Planning Commission

Regular Meeting Agenda

Frances Meaders Council Chambers
151 Willowbend Road
July 28, 2025 | 6:30 PM

SUBJECT: Building Elevations, J. Alexander's, 100 Market Place Blvd.

Below are before and after images of the building:

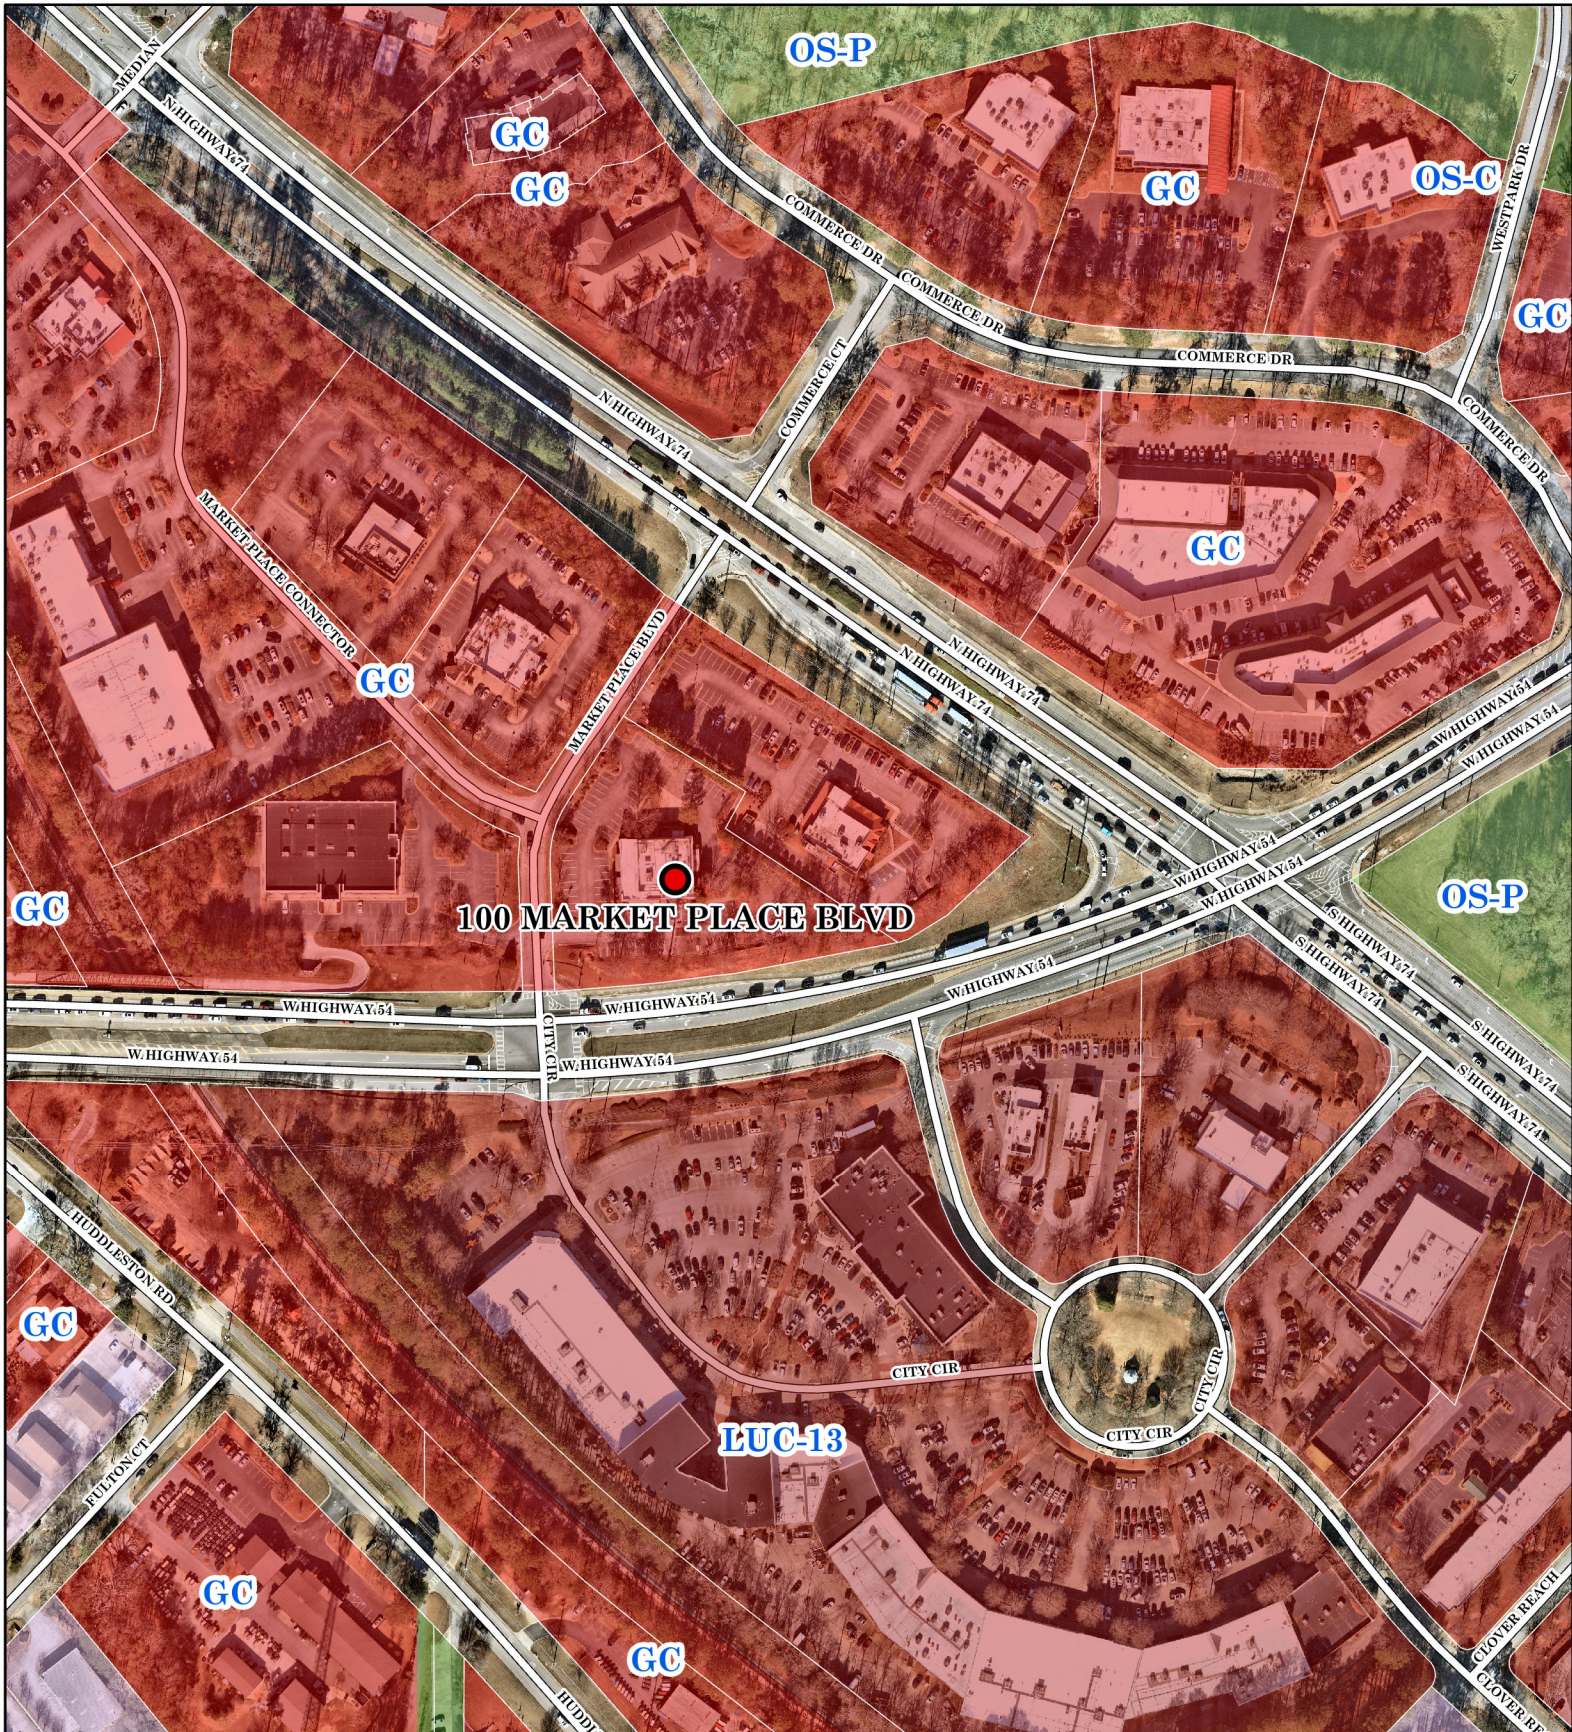
Per Section 725 of the LDO, front facades should be 80% primary materials (ie. brick or stone) and side facades should be at least 50% primary materials. Since stone is considered a primary material, the change from brick to stone on the sides and rear of the building will not change the amount of primary materials. All three sides will remain 100% primary materials. The front facade proposes a small reduction of primary materials, replacing a portion of the existing brick with EIFS. The new amount of primary materials on the front facade is 77%.

The design guidelines for the overlay district specify materials and colors for architectural finishes. Colors and materials proposed shall be substantially the same or equal to those specified in the guidelines. The colors and materials proposed for the building upgrades are as follows:

Staff feels the proposed colors and materials are substantially the same as those listed in the design guidelines.

Front Elevation

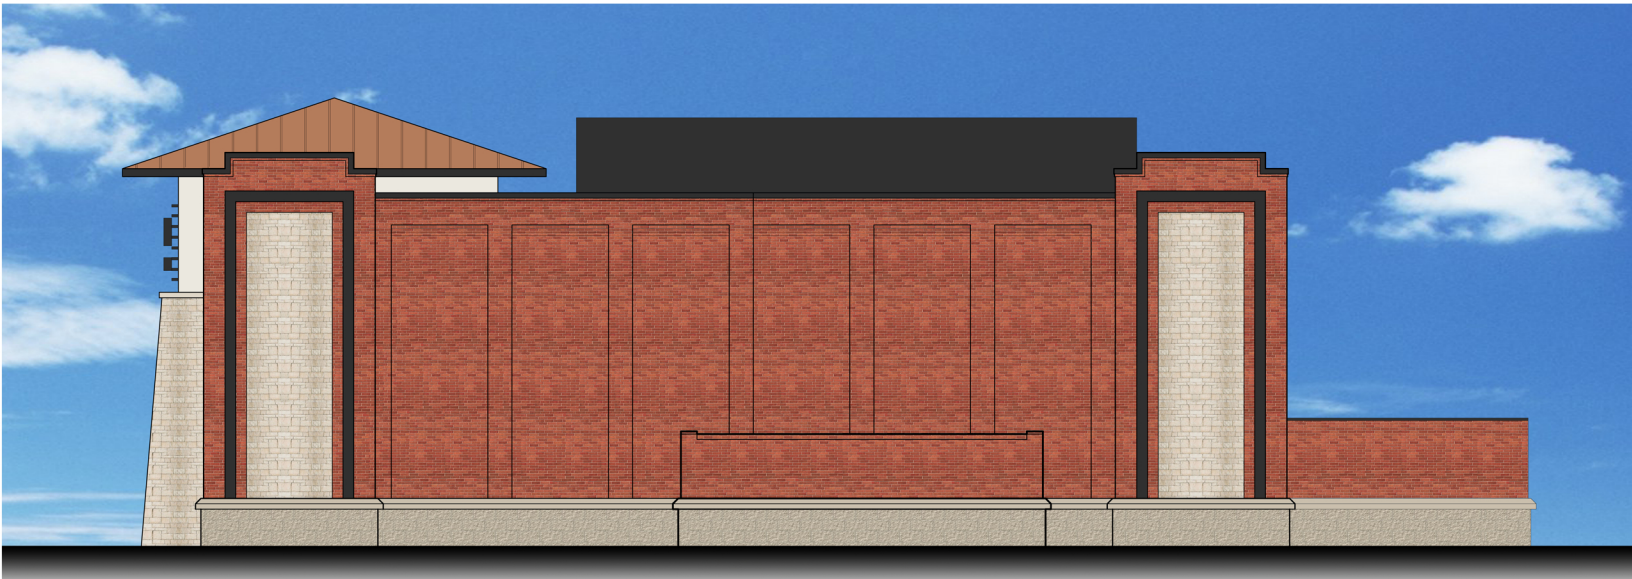
While the front facade materials fall short of the 80% requirement for primary materials by a small percentage, Staff feels the proposed building elevation modifications for 100 Market Place Blvd. meet the remaining requirements of the ordinances and development requirements for Peachtree City.

Staff feels the redesign of the entrance and the stone veneer added to emphasize the architectural features at the building corners meet the design guideline requirements.

LANDSCAPE PLAN/
CALCULATIONS

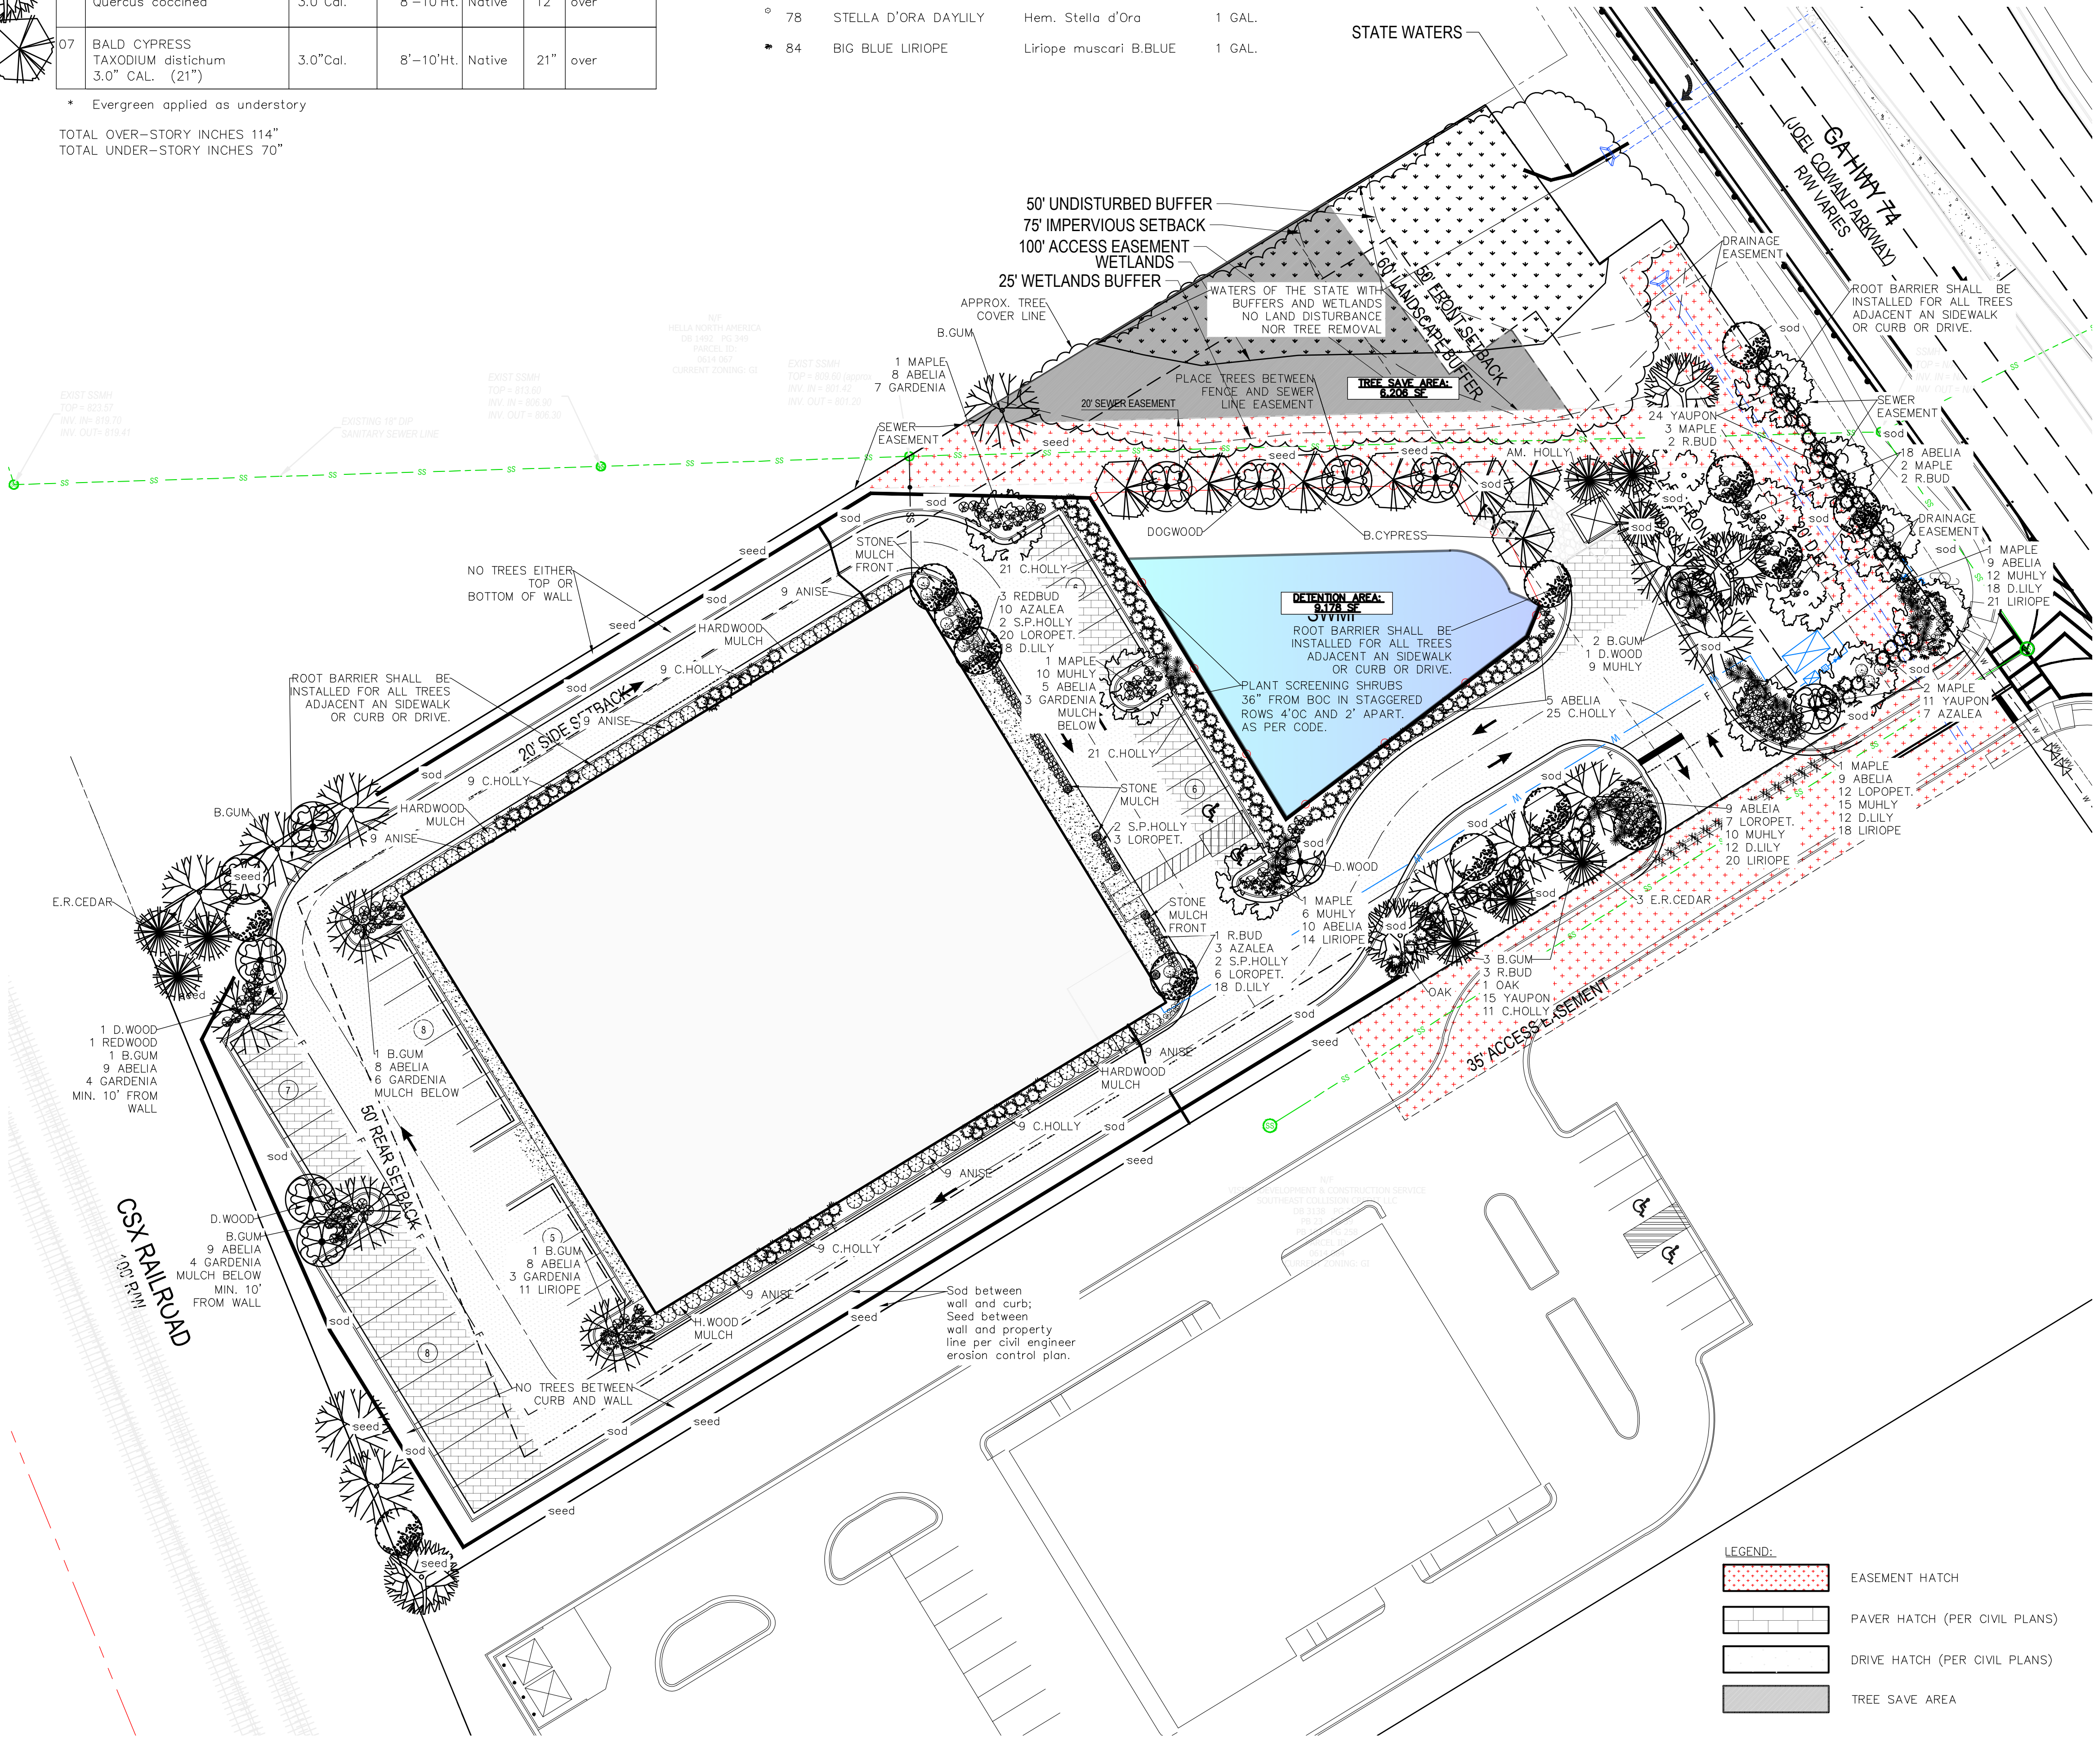
Based on the amount of impervious surface area (70,132 SF), including new structures, drives, parking areas, and sidewalks, the landscape ordinance requires 210 caliper inches of canopy trees and 138 inches of understory trees.

Per Section 1110(e) of the Land Development Ordinance (LDO), preservation of existing vegetation is highly encouraged. The Planning Commission may permit up to a 25% reduction in the total number of trees required by the ordinance.

The applicant is requesting a reduction of 5% for 6,206 SF of tree area preserved. If approved, the reduction would reduce the caliper inch requirements to 200 inches of canopy trees and 131 inches of understory trees.

The proposal is for 114 inches of canopy trees and 70 inches of understory trees. A minimum of 50% of the canopy and understory tree requirement must be provided before an alternative compliance method may be requested.

Section 1114.5 of the LDO permits the tree fund compliance method after all the trees that can be reasonably planted on the site are provided. It is the opinion of Staff that this requirement has been met.

Staff is of the opinion the landscape plan for the self-storage facility located at 425 HWY 74 S meets the requirements of the City ordinances and development standards.
